SB-10045284-7762SI B18 05 12
Exhaust SystemsJuly 2012
Technical Service

Voluntary Emissions Recall Campaign 11E-A03: Check and/or Replace Emissions Monitoring Components

NEW E70 and E90 with the M57Y engine produced from April 2009 to September 2010

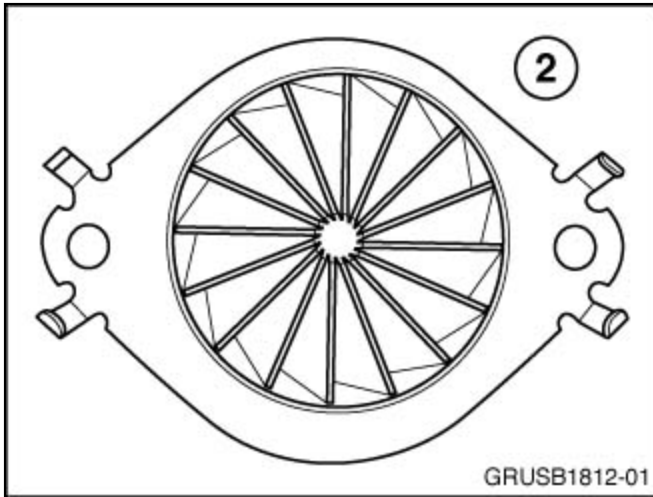
The original style mixer has a multiple fin arrangement (1). This mixer will need to be replaced with P/N 18 30 8 513 445 (E70) or P/N 18 30 8 512 438 (E90).

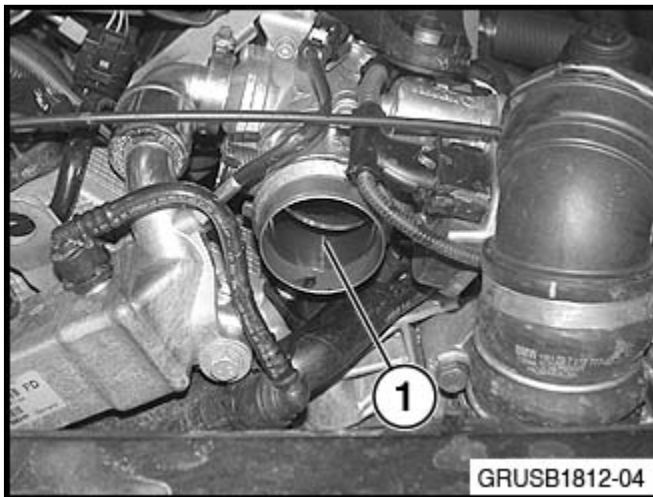
If the updated mixer has already been installed, it will have one set of fins (2). No replacement is necessary. Reinstall

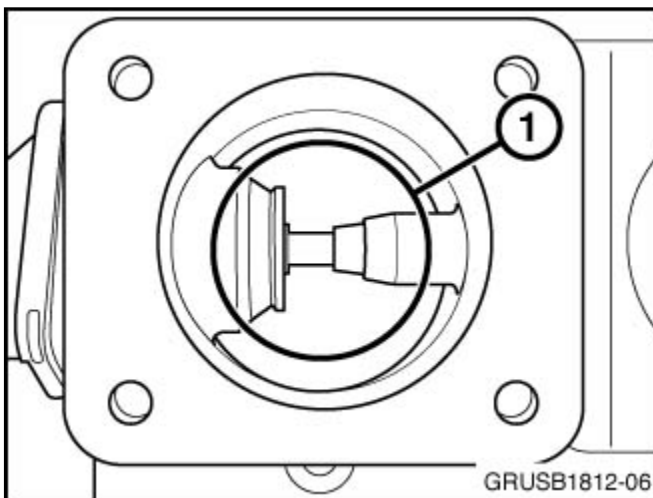
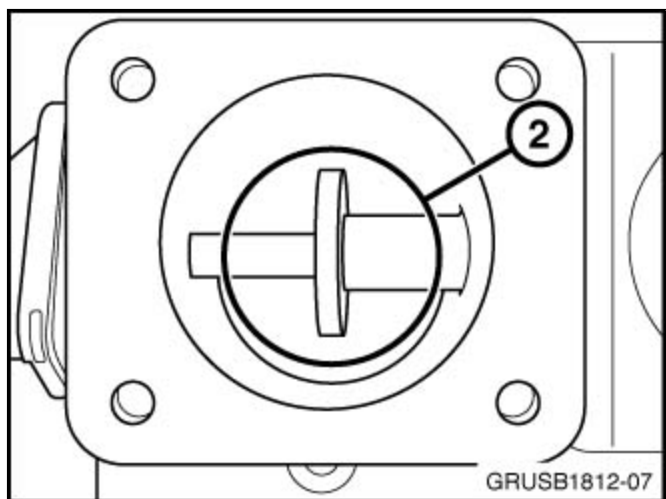
Remove the charge air pipe at the throttle housing (ignition off). Using a flashlight, look through the throttle (1) and inspect the EGR valve.

The updated EGR valve (P/N 11 71 8 517 217 or P/N 11 71 8 512 526) has the valve and seat directly in the airstream of the throttle (1). If this valve is installed, no further action is needed. Reinstall the charge air pipe.

The original EGR valve has a diffuser in the airstream flow from the throttle (2). The valve for EGR actuation is seated further into the EGR airstream. Replace this valve with P/N 11 71 8 512 526 (Repair Instruction 11 71 501).

The DDE will also need to be programmed as part of the Recall. If the EGR valve is replaced, the DDE will need to be programmed after the new EGR valve is installed. This new software package contains the necessary software to adapt to the new EGR valve strategy.
